8802050154 880201
PDR ADDCK 05000400
PDR

SHEARON HARRIS NUCLEAR POWER PLANT
NRC DOCKET NO. 50-400
OPERATING LICENSE NPF-63
REQUEST FOR LICENSE AMENDMENT

BASIS FOR CHANGE REQUEST
INCREASED F-DELTA-H MULTIPLIER

FIGURE 2.1-1

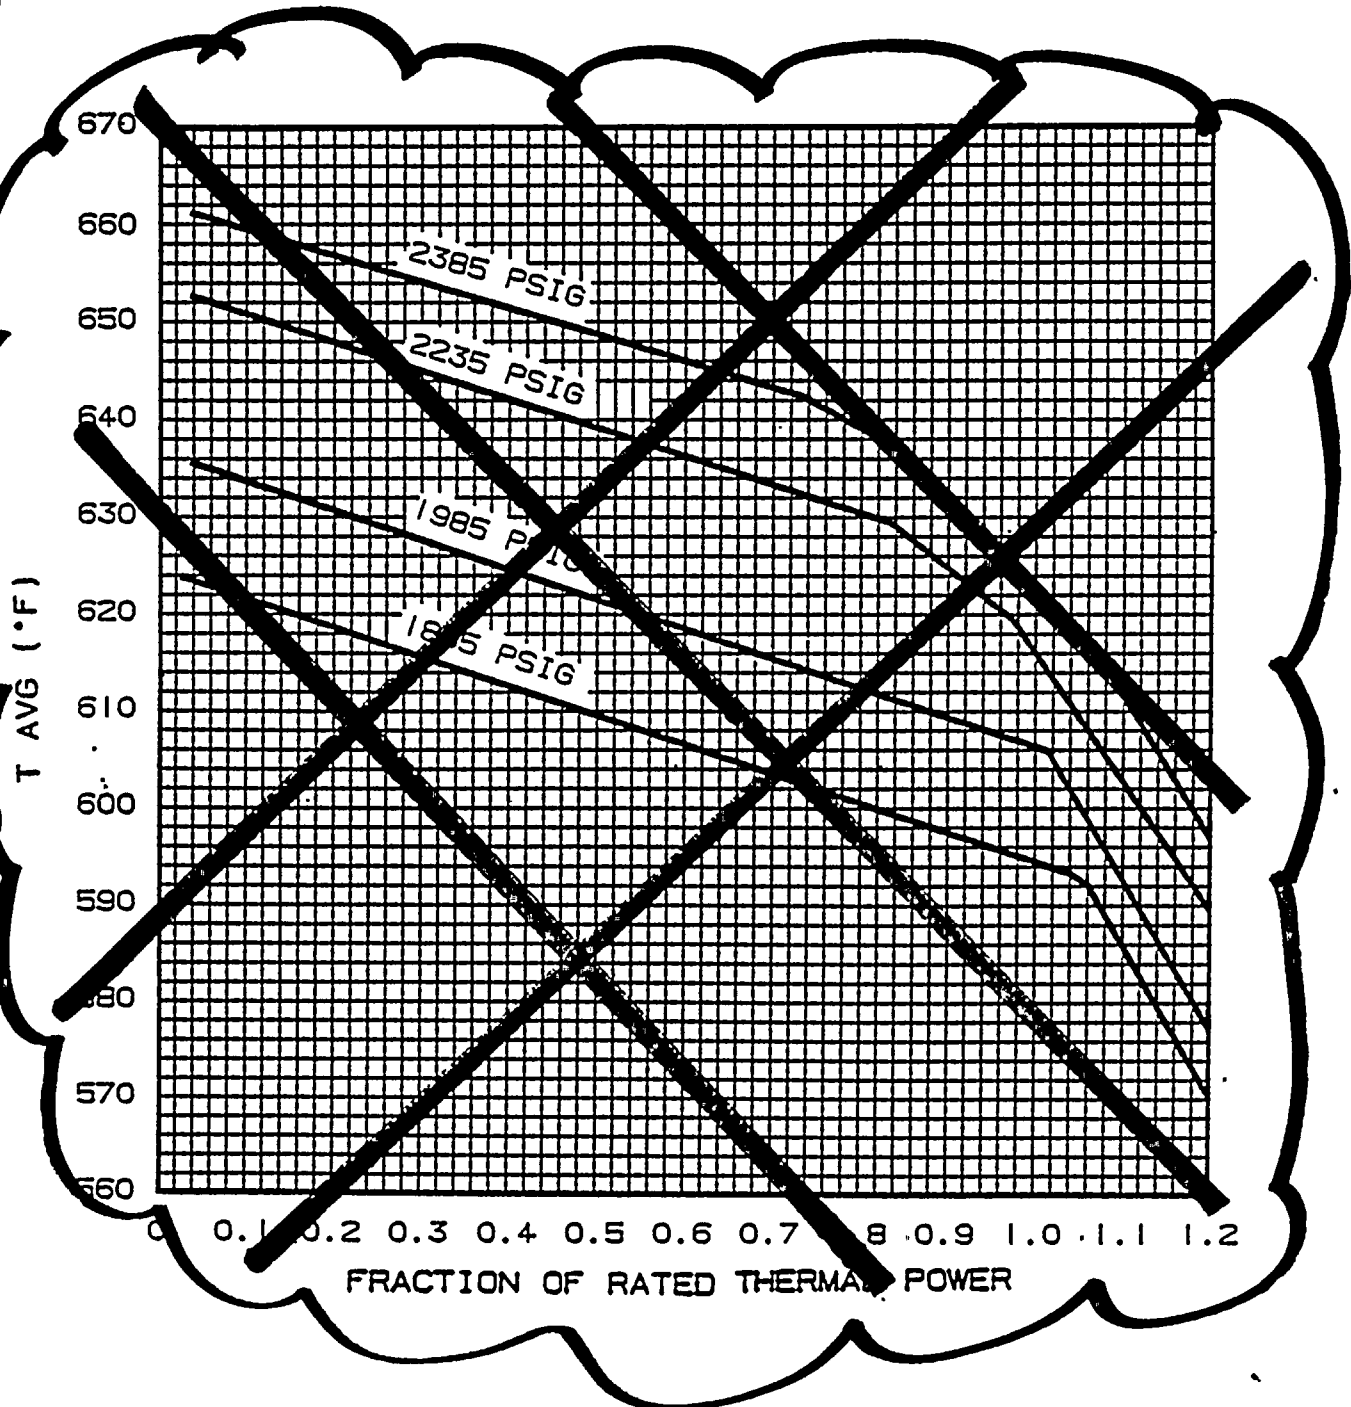
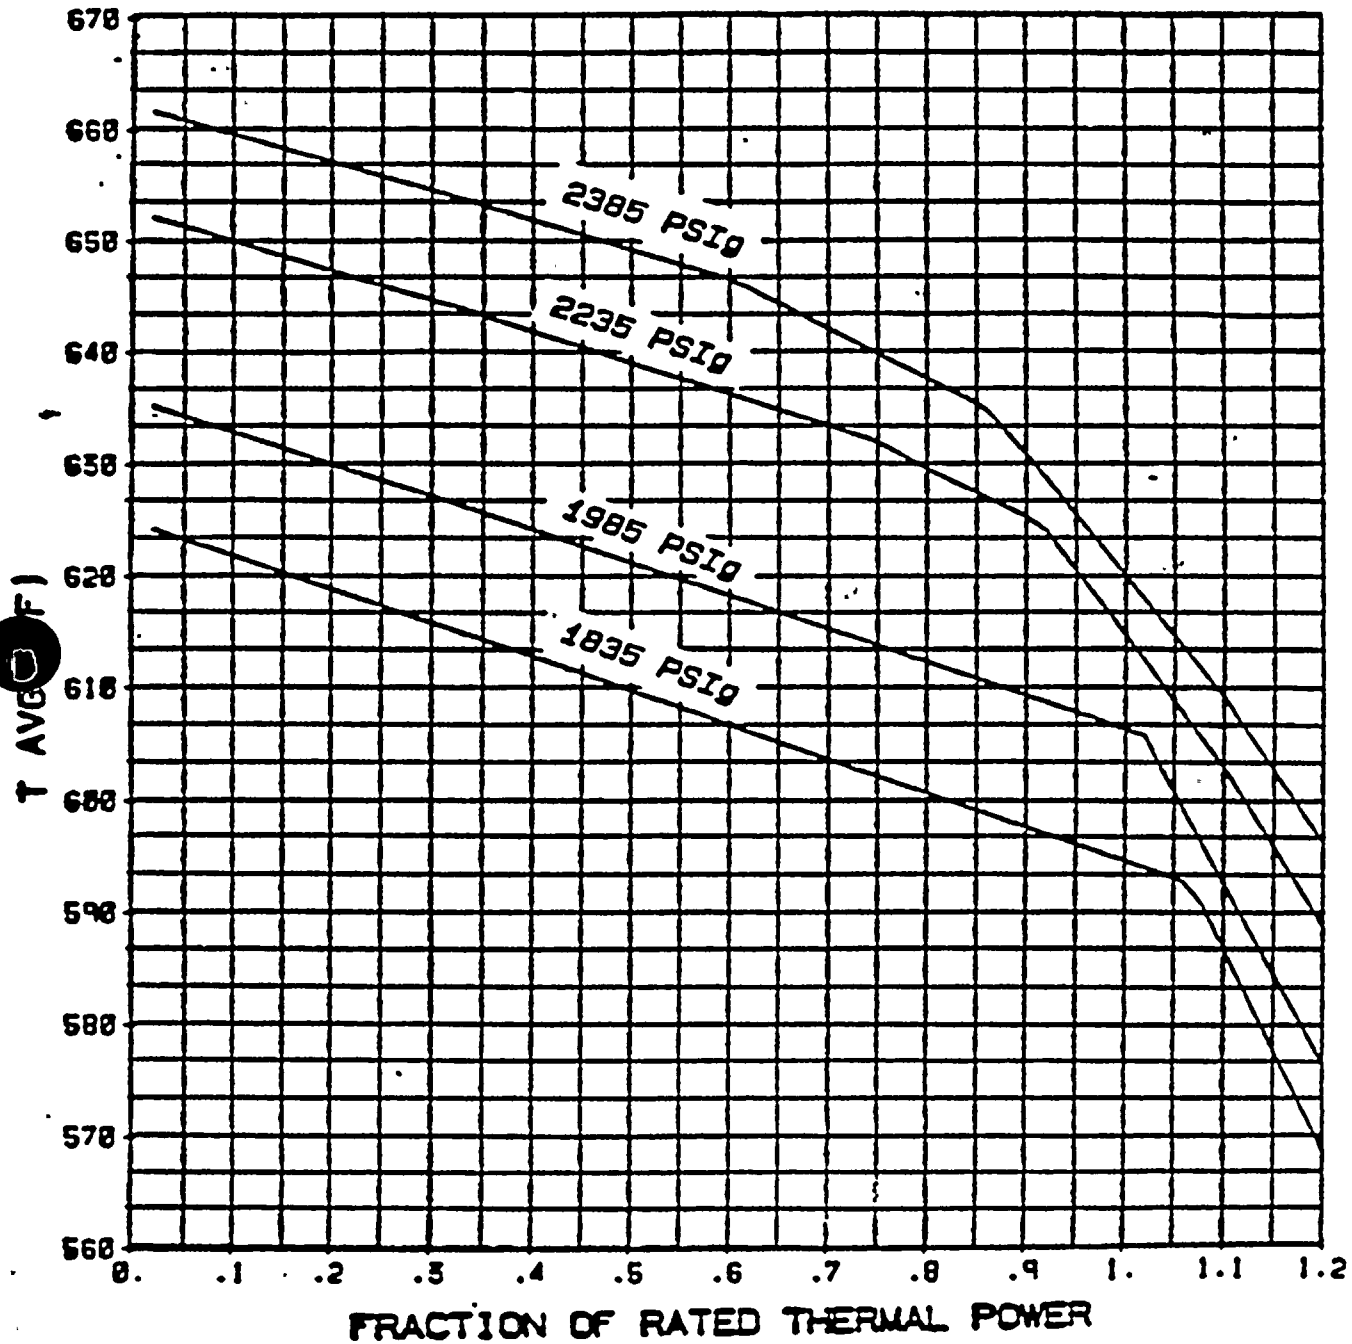
REPLACE WITH ATTACHED INSERT

INSERT FOR FIGURE 2.1-1

FIGURE 3.1-1
ROD GROUP INSERTION LIMITS VERSUS THERMAL POWER THREE-LOOP OPERATION

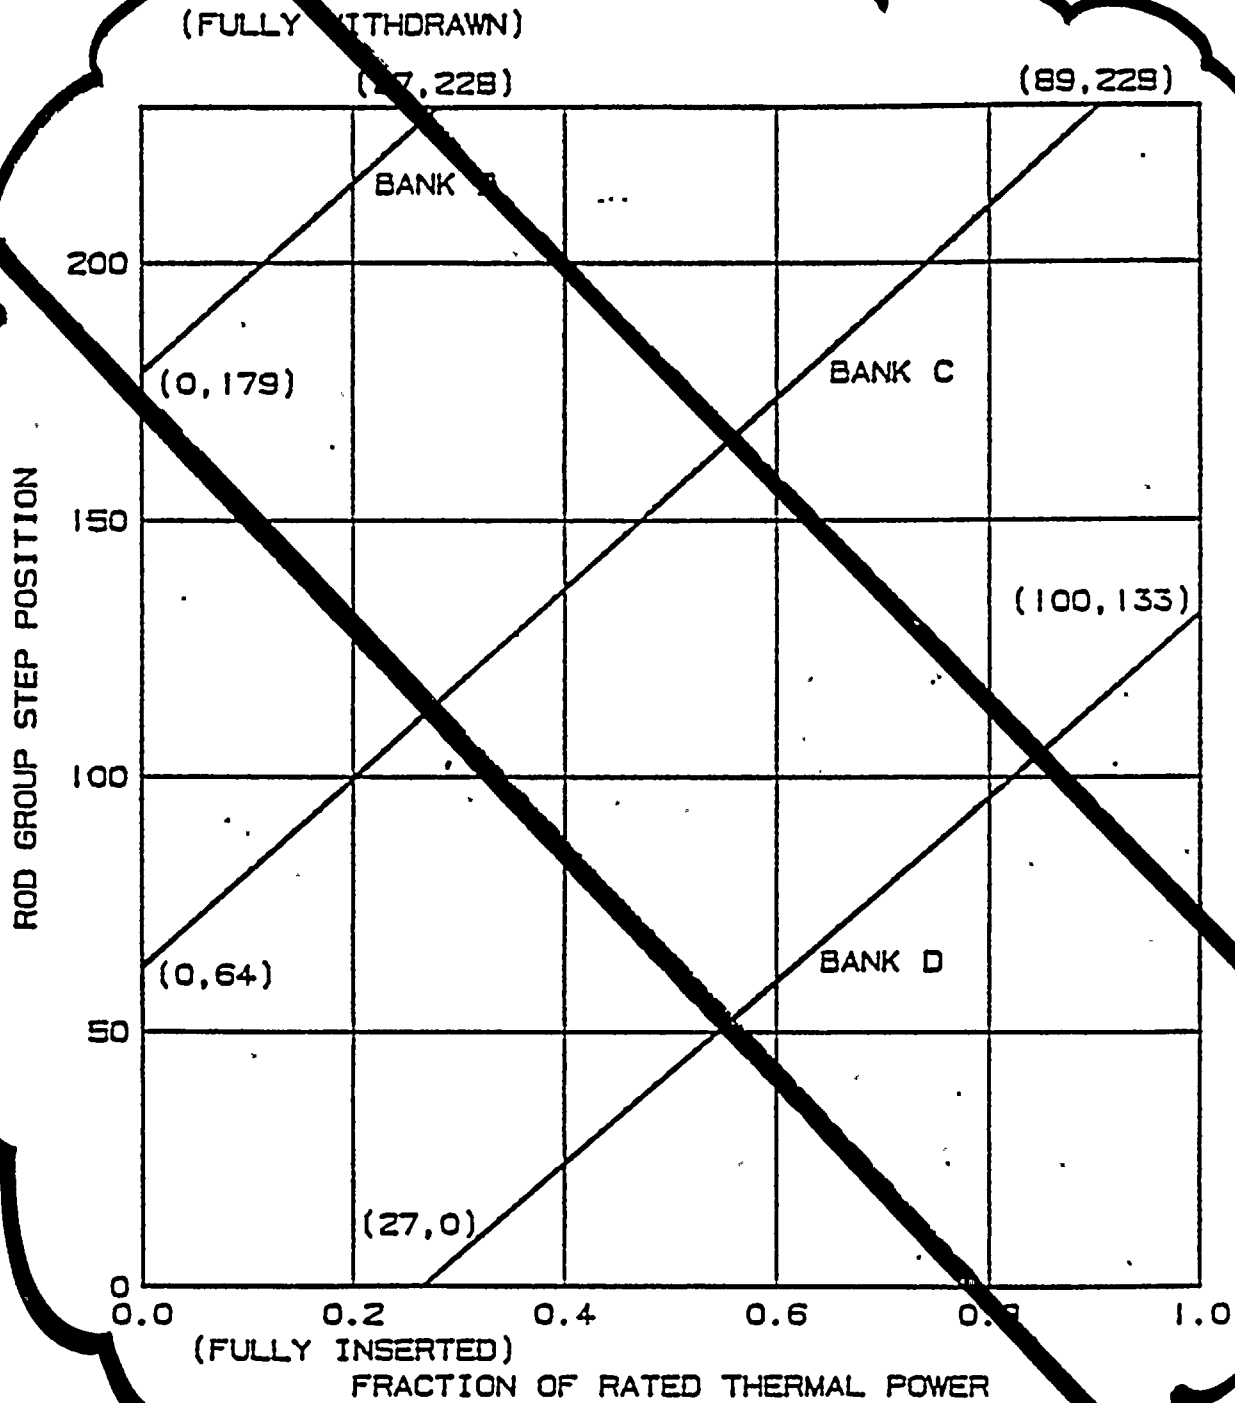
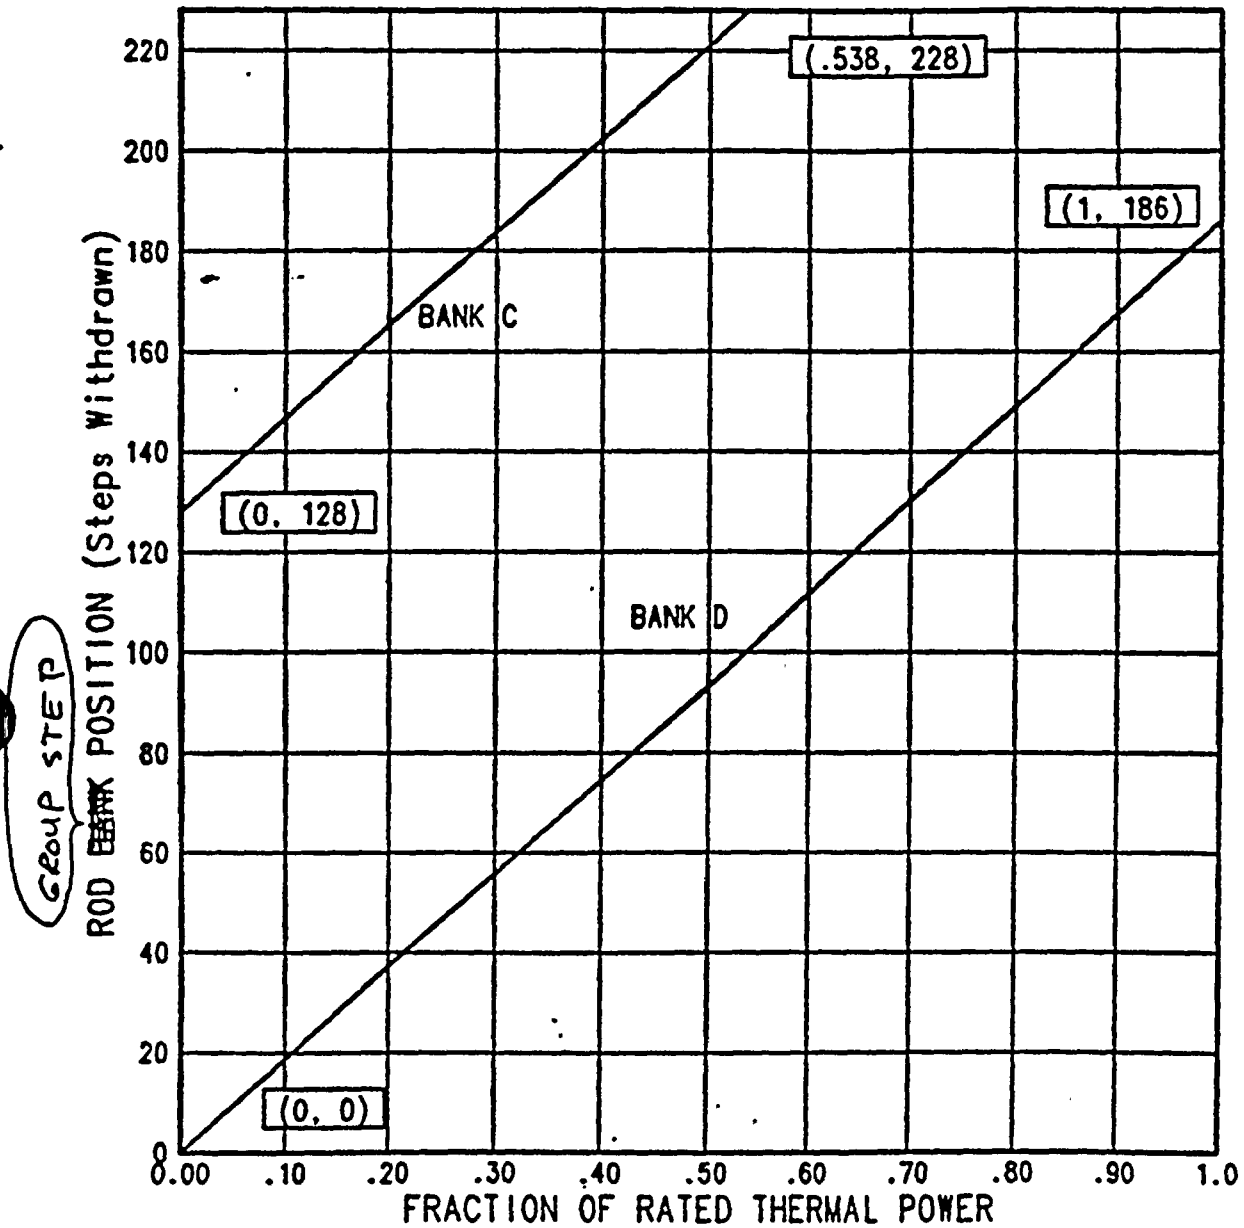
REPLACE WITH ATTACHED
